IEEE 802.11
Wireless Access Method and Physical Layer Specification

Title: Recommendation Modification of Proposed Wording of the Physical Layer Draft Specification for 2.4 GHz Draft Frequency Hop Spread Spectrum Media, Doc 94/68, March 1994

Author: Jim McDonald
Motorola, Inc.
50 E. Commerce Drive Suite M-2
Schaumburg, Ill 60173
Tel: 708 576 3169
Fax: 708 576 8585

Figure 4-2. Occupied Channel Bandwidth.

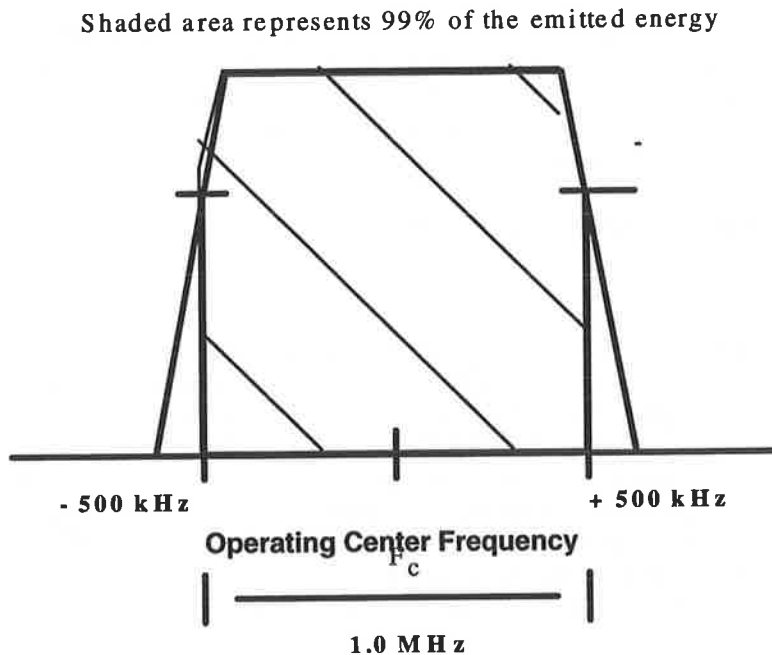
In the May 1993 meeting, the FCC requirement for a 20 dB bandwidth of less than 1 MHz was discussed. It was recognized at that meeting, that the FCC specification might refer to the bandwidth of 99% of the transmitted power or the more demanding requirement that the spectrum to be down at least 20 dB at ± 500 KHz from the transmitted center frequency. Rather than presume the FCC intent, it was decided to provide a modulation format, GFSK, with a minimum deviation of ± 160 kHz. If the FCC would ultimately rule that the 20 dB bandwidth prevailed, then the maximum deviation would be ± 175 kHz. If the FCC would ultimately rule that the 99% occupancy interpretation of bandwidth would prevail, then the deviation maximum would be ± 210 kHz.

The FCC rules do not state or imply specific center frequencies for frequency hop transmitters in the 2.4 to 2.4835 MHz band. The occupied bandwidth of a transmitter need not be reference to any given center frequency for FCC reasons. For interoperability reasons, the center frequency must be defined

for the 802.11 specification with tolerance. In terms of complying with the FCC bandwidth restriction, only the bandwidth of the transmitted signal need be considered. There is no need to reference the IEEE 802.11 frequencies or the tolerance this standard allows with respect to these nominal frequencies. These are separate issues.

The transmitter center frequency shall be within ± 25 ppm of one of the specified operating center frequencies listed in section 4.7.3. The following diagram illustrates the relationship of the operating channel transmitter center frequency (defined as F_c) to the occupied channel bandwidth.

4.7.4 Occupied Channel Bandwidth. (CLOSED: A.3) The occupied channel bandwidth for the PMD is 1.0 MHz wide, as specified at the -20 dB points of the associated signal spectrum. This 1.0 MHz envelope must contain 99% of the emitted energy, as measured at the ± 500 kHz frequency limits from the transmitter center frequency. The FCC may impose a further restriction on transmitted bandwidth requiring the 20 dB bandwidth, as measured with a spectrum analyzer and referenced to the magnitude at the center of the transmitted bandwidth, to be less than 1 MHz.

(Replacement Figure)

The motion is made to adopt this proposed new wording for paragraph 4.7.4 of the Physical layer specification.
